Administrative Staff Report

Project Name: ROBERTS - Critical Area Buffer Reduction for Single-Family Residence

Type of Application: Critical Area Buffer Reduction

Permit Number: 24-01694

6. Site Design

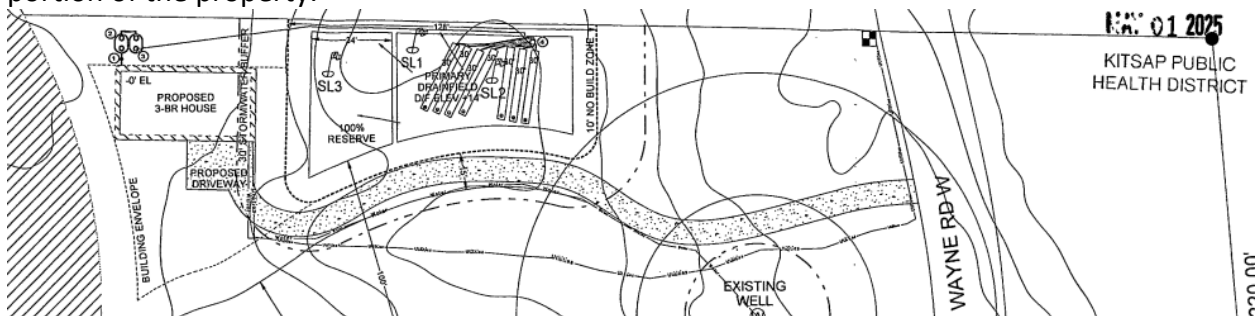
The image below shows the proposed footprint of the 1,595 square-foot home with attached garage, an associated drainfield, residential parking, and located on the northernmost portion of the site with a proposed driveway accessing from the eastern portion of the property.

Issue Ref. No.	Summary of Concern
1	Public Comments 7/15/24 - Ecology determined that habitat score is 7 rather than 5, delineating wetland as CAT I. Move house further east to avoid wetland A encroachment and possibly additional mitigation.

Both the house and the reconfigured drainfield are located outside the buffer of Wetland A. As a result, the current layout meets the avoidance requirement and does not impact Wetland A or its buffer.
